STAFF REPORT
COMMUNITY DEVELOPMENT DEPARTMENT

DATE: 12/2/2025
TO: City Council
FROM: Sonya Allen, Associate Planner
208-884-5533
sallen@meridiancity.org
SUBJECT: FP-2025-0007
Reveille Ridge No. 1
PROPERTY LOCATION:
7355 S. Eagle Rd., in the east 1/2 of
Section 5, T.2N., R.1E.

Final plat consisting of 68 buildable lots and 23 common/other lots on 18.32 acres of land in the R-8 and R-15 zoning districts for the first phase of Reveille Ridge Subdivision.

B. Final Plat (dated: 11/4/25)

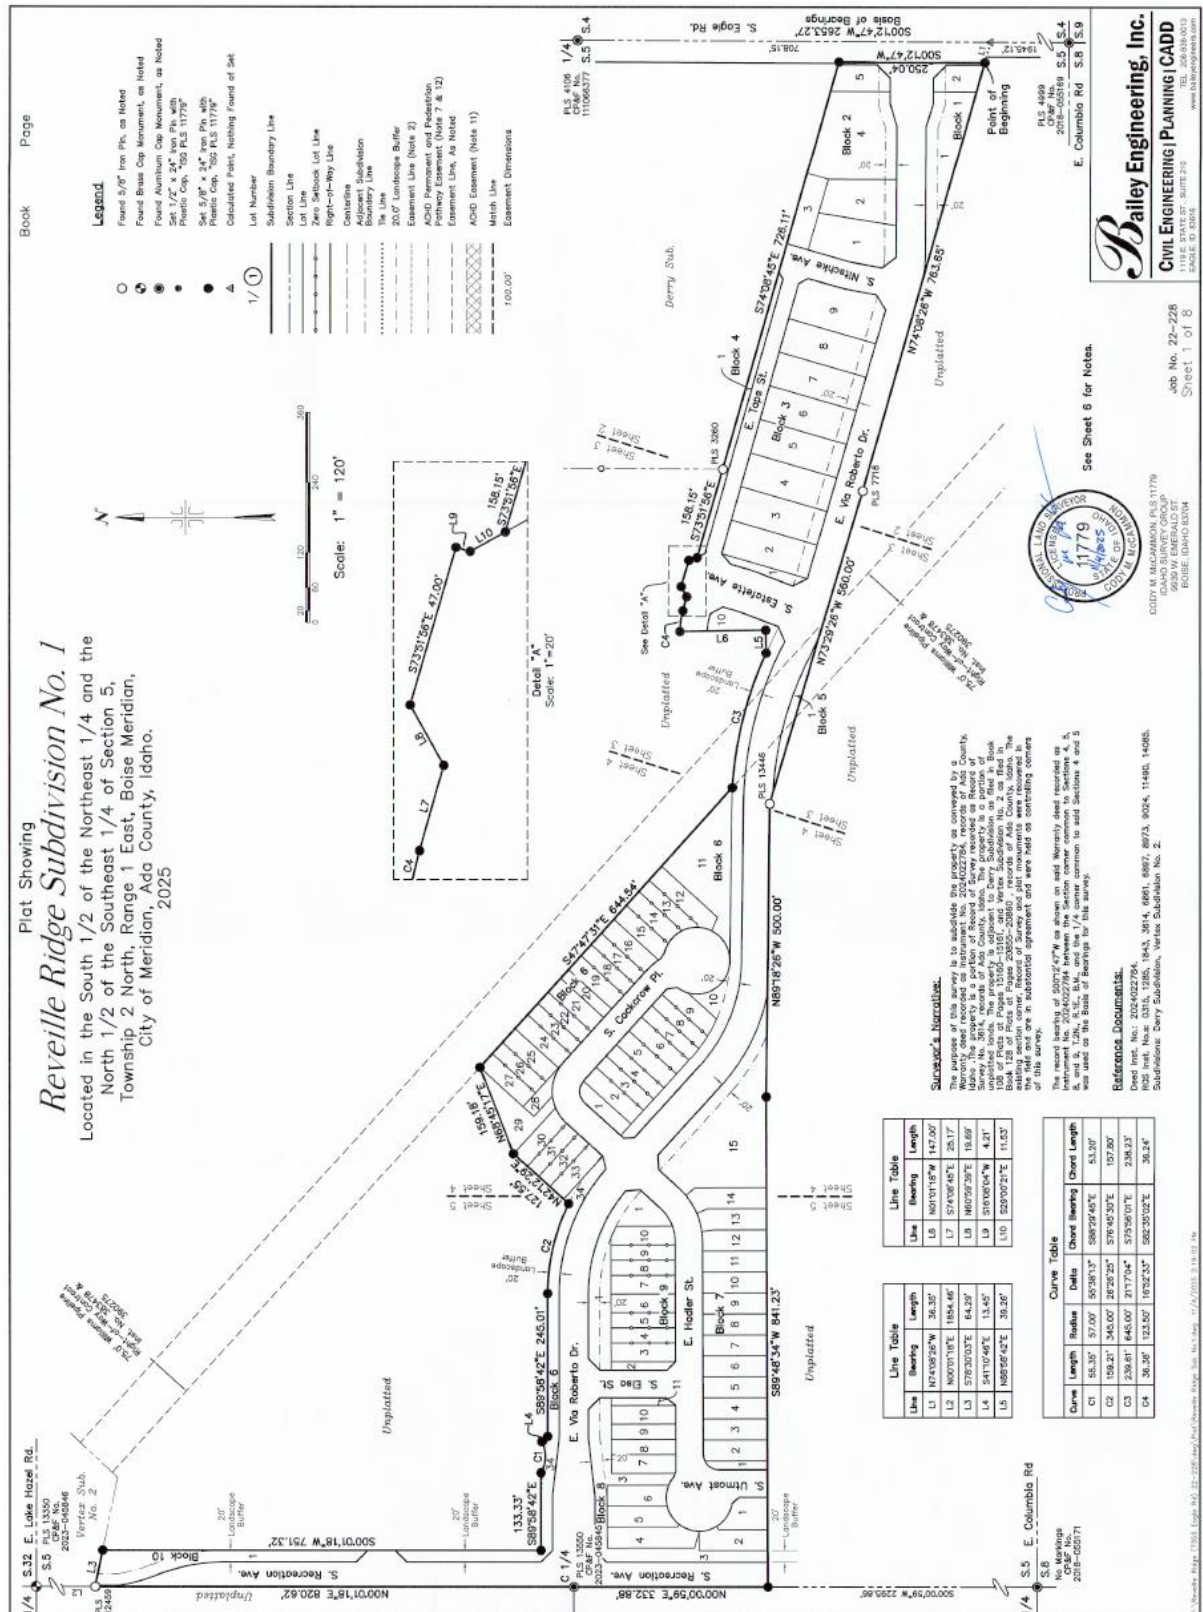
3. Prior to submittal for the City Engineer's signature, have the Certificate of Owners and the accompanying acknowledgement signed and notarized.
4. The final plat prepared by Bailey Engineering, Inc., stamped on 11/4/25 by Cody M. McCammon, included in Exhibit B shall be revised as follows:

- a. Note #7: Include recorded instrument number of ACHD permanent easement.
 - b. Note #8: Include recorded instrument number of ACHD temporary license agreement.

- c. Note #9: Lot 16 (Block 7) should be Lot 15 and Lot 12 (Block 8) should be Lot 11.
 - d. Note #12: Include the recorded instrument number of the pathway easement.

- e. Modify Note #14 as follows: "Direct lot/parcel access to S. Eagle Rd., E. Via Roberto Dr. and S. Recreation Ave. is prohibited."
 - f. The construction plans shall depict a 10-foot-wide detached sidewalk/pathway along *all* lots on the south side of E. Via Roberto Dr. (where there is adequate area) per preliminary plat condition #2c. Parkways shall comply with the standards listed in UDC 11-3A-17E.

- g. Remove the street name (i.e. E. Taps St.) on the south side of Lot 1, Block 4 as it is an alley and can't be named.
5. The landscape plan prepared by Jensen Belts Assoc., dated 12/30/24 included in Exhibit C, shall be revised as follows:

FINAL PLAT LANDSCAPE PLAN

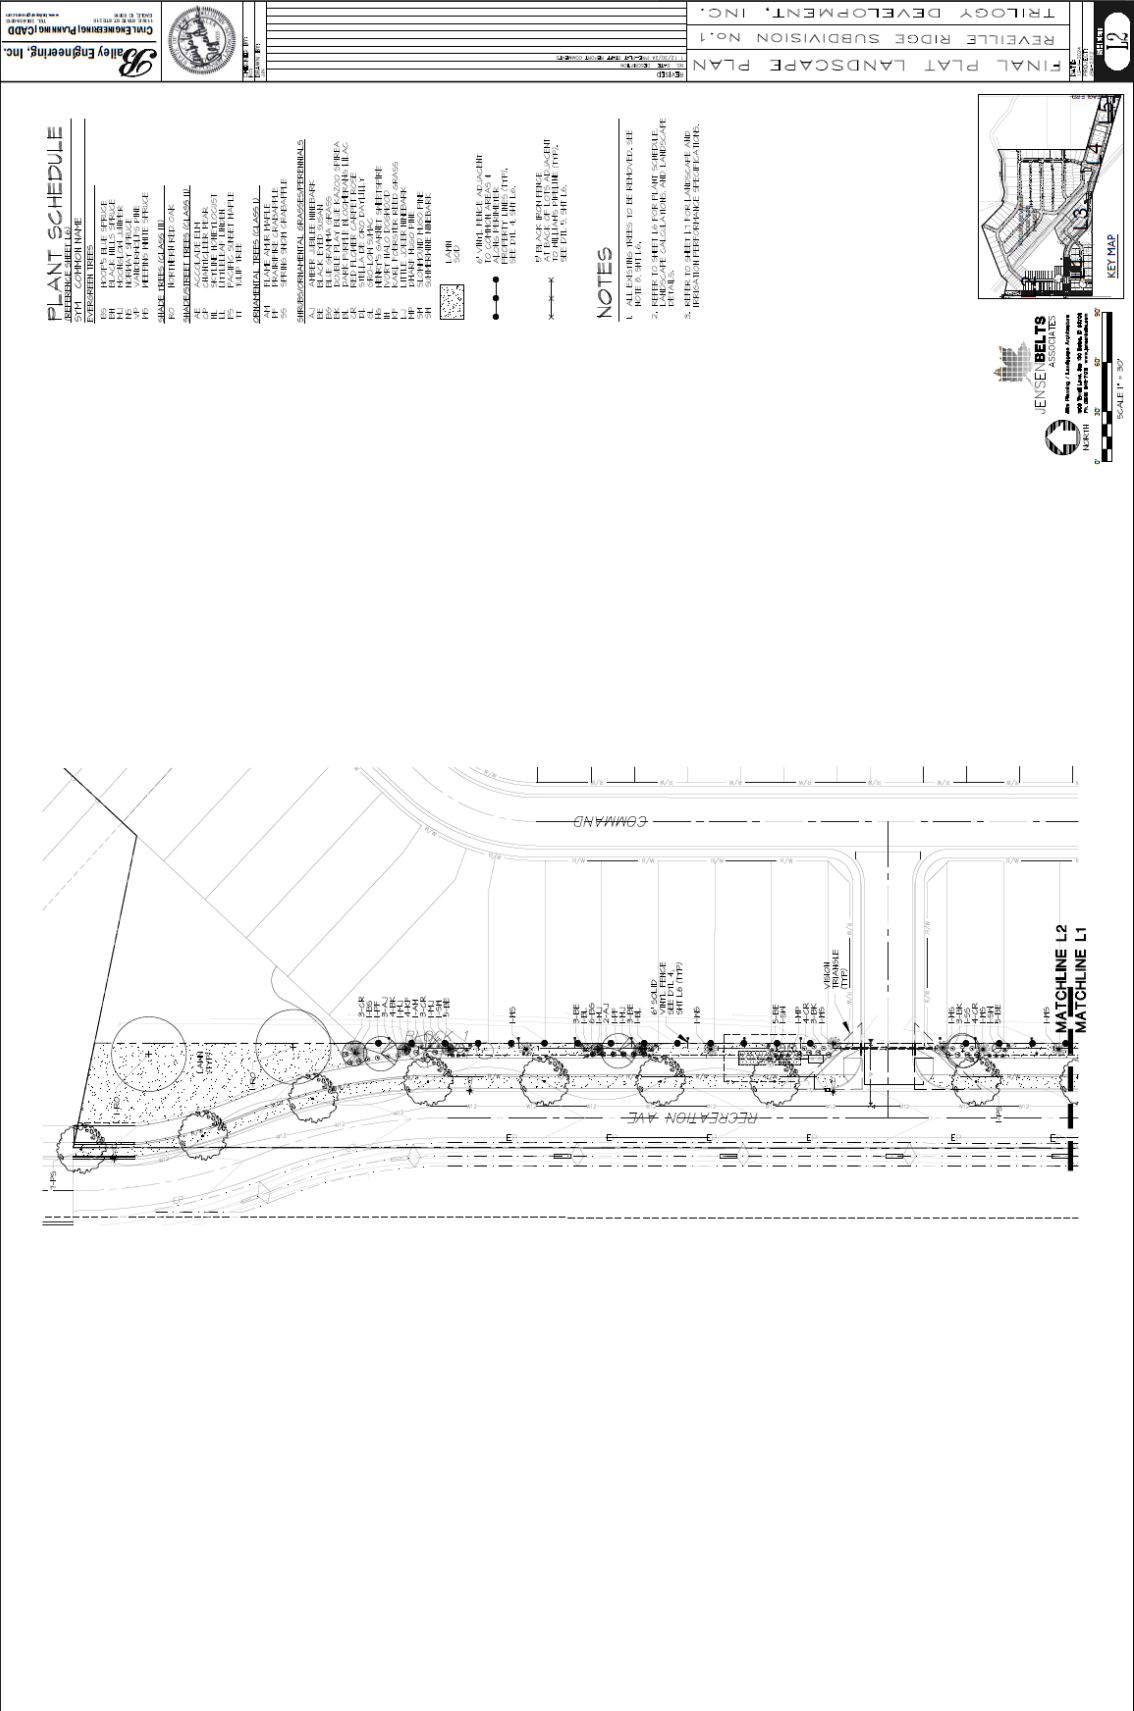
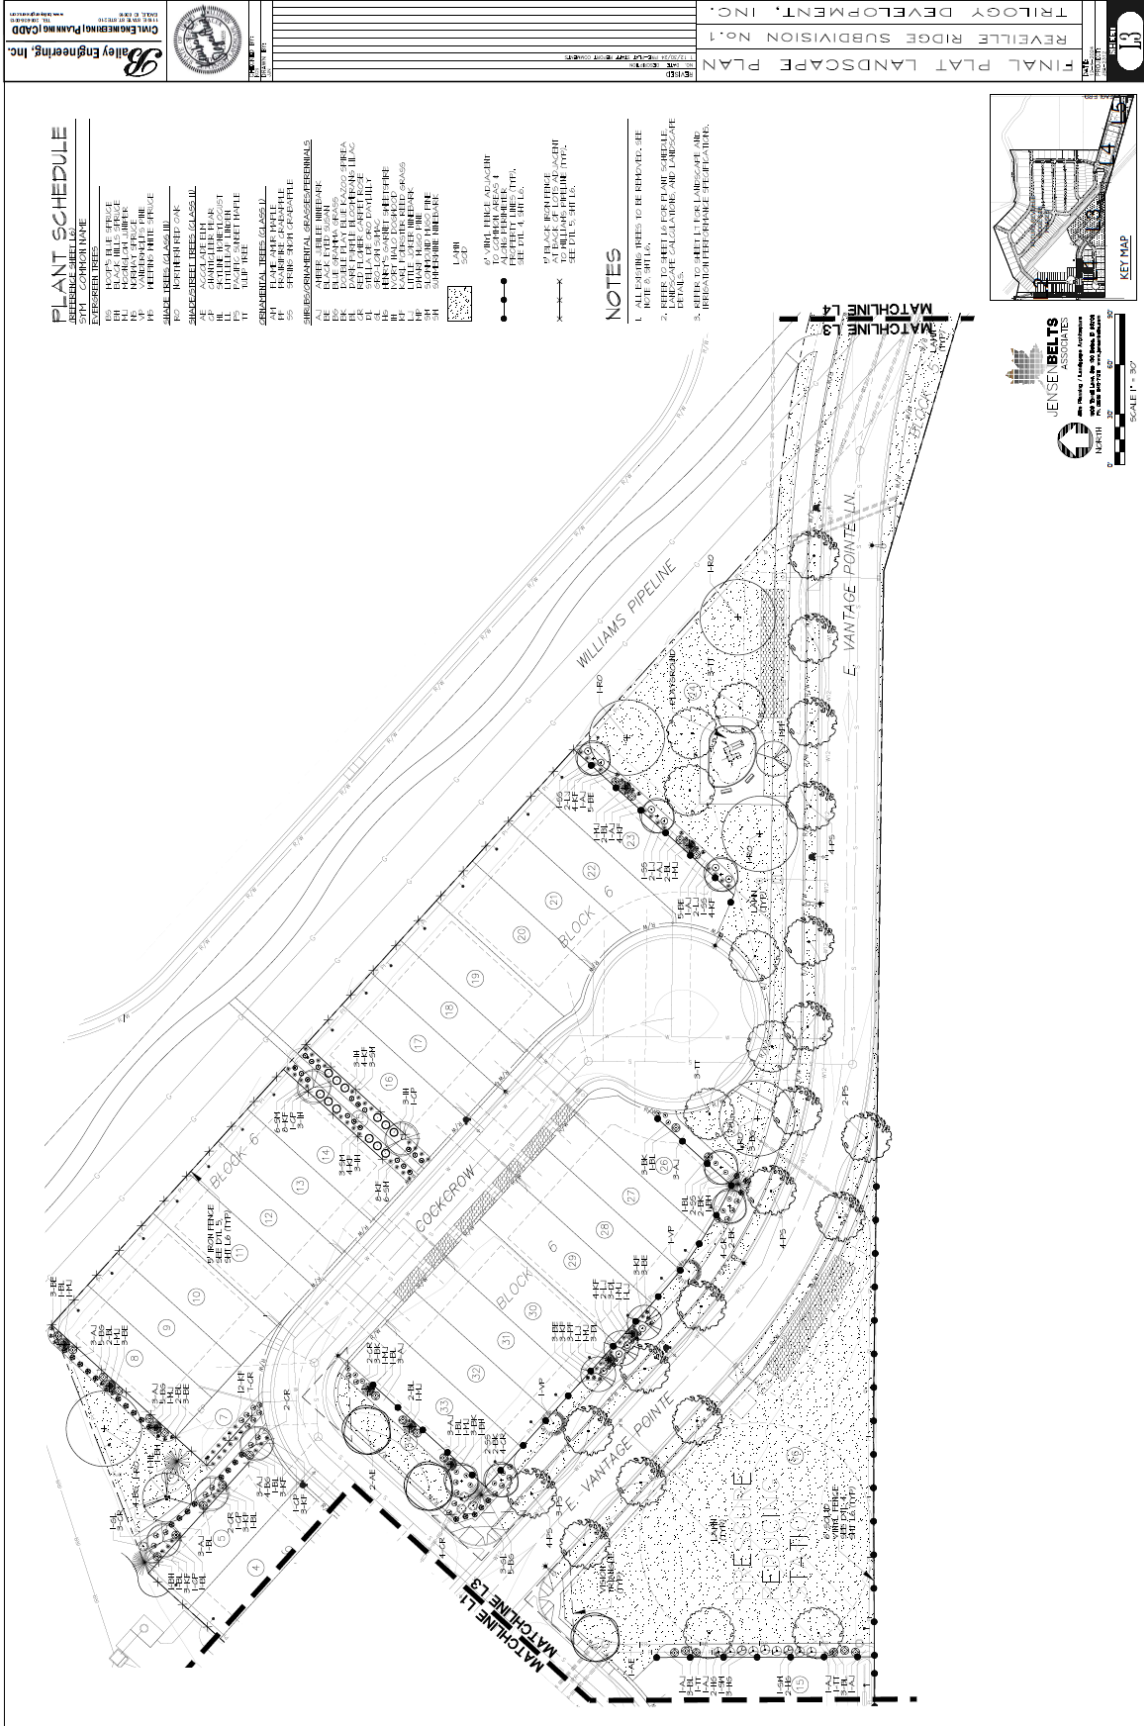
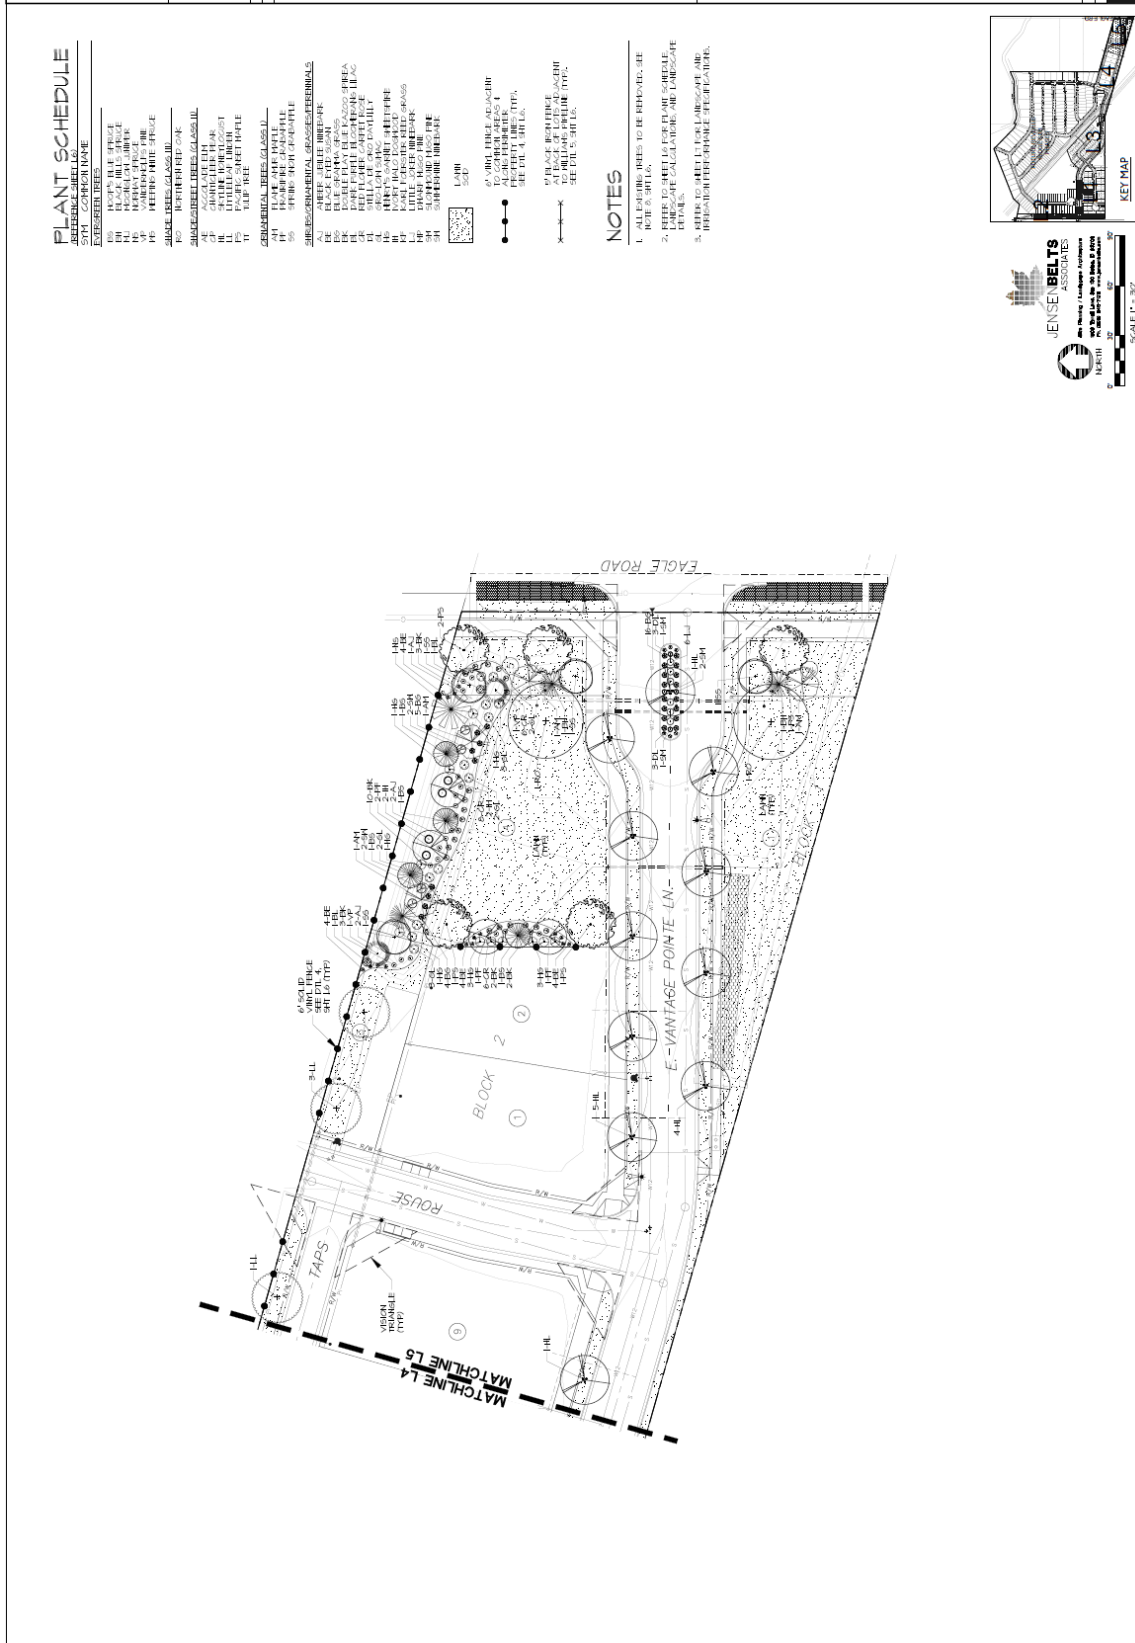
- a. Correct the edge of pavement (EP) depicted on Lot 3, Block 2 consistent with that depicted on the common driveway exhibit.
 - b. Change the E. Vantage Pointe street name to E. Via Roberto Dr. consistent with the final plat and remove the alley street name (i.e. E. Taps St.).

- c. Depict a 10-foot-wide detached sidewalk/pathway along the south side of E. Via Roberto Dr., a collector street, in accord with development agreement provision #5.1b.

- d. Change the lot numbers consistent with those depicted on the final plat.
 - e. Depict landscaping with a *mix* of materials (i.e. shrubs and vegetative groundcover) *within* the required street buffers along S. Eagle Rd. and E. Via Roberto Dr. on Lot 15, Block 7; Lot 1, Block 5; Lots 2-9, Block 3; Lots 1, 2, 4 and 5, Block 2; and Lots 1 and 2, Block 1, in accord with the standards listed in UDC 11-3B-7C.3.

- f. Extend the 10-foot wide multi-use pathway to the south through Lot 1, Block 5 for future extension to the south.
6. Submit a 14-foot wide public pedestrian easement for the multi-use pathway within the Williams Pipeline easement and along the Farr Lateral, as required by the Park's Dept. *Note: The pathway only crosses Lot 1, Block 4 on this site but the entire easement can be included, including the portion(s) not included in this phase.*

**LOT 3, BLOCK 2
SHARED ACCESS FOR
LOTS 1 & 2 BLOCK 2**
1"=40'

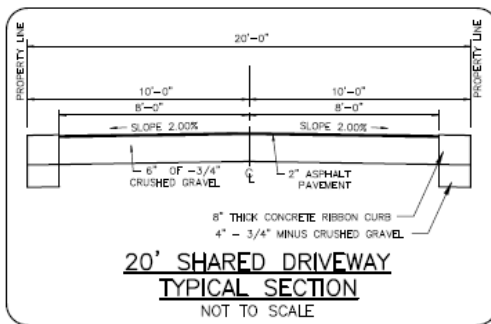
9. Future development of Lots 1 and 2, Block 2 and Lots 25-27, Block 6 shall be consistent with the common driveway exhibit included in Section V.E and the standards listed in UDC 11-6C-3D.
